REVISION 004 TO A REQUEST FOR PROPOSAL

| Title - Sujet : Park Entry Pass System – Pacific Rim National Park Reserve | | |
| Solicitation No N° de l'invitation : 5P420-19-0320/A | Date: December 09, 2019 | |

Amendment 004

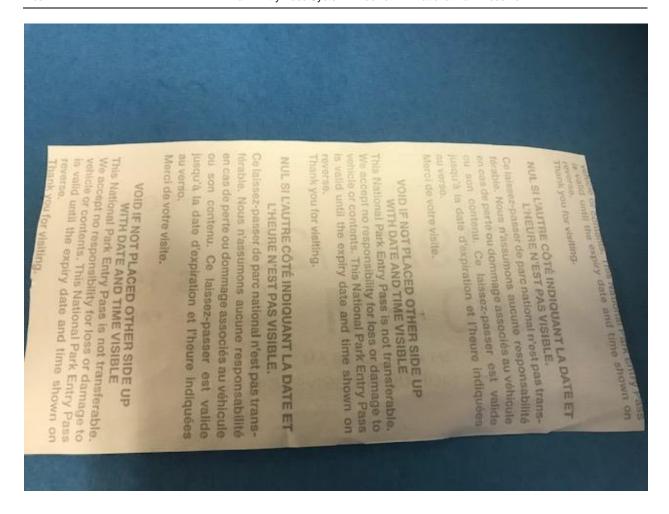
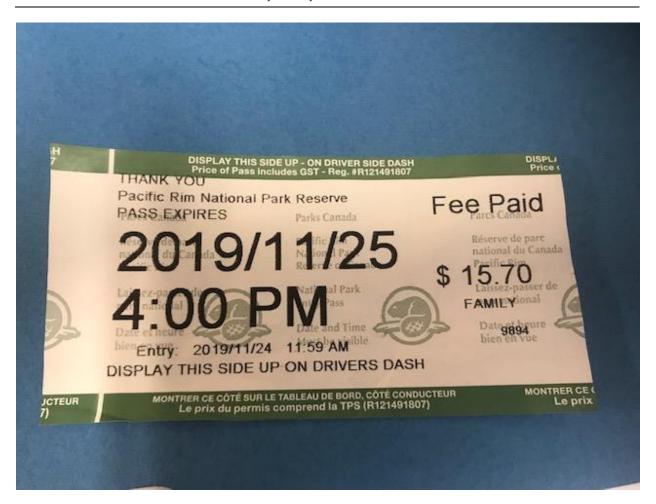
- Q5. PCA would like the Park Entry Pass Machine to have the capacity to produce a minimum of 3,500 permits before replacing the paper. Can you specify the length of the permits, based on the information in section 3.8.2, would a minimum of 3" be sufficient?
- **A5**. While 3" is quite short, if the bidder can guarantee that all the information required will be included and it will be legible for compliance officers checking in the windshields, then it will be sufficient. Note that there needs to be a bit of space at the bottom as tickets fall down behind the dash and need to be visible from the outside of the vehicle. Please see the attached pictures of the current permits for reference only.
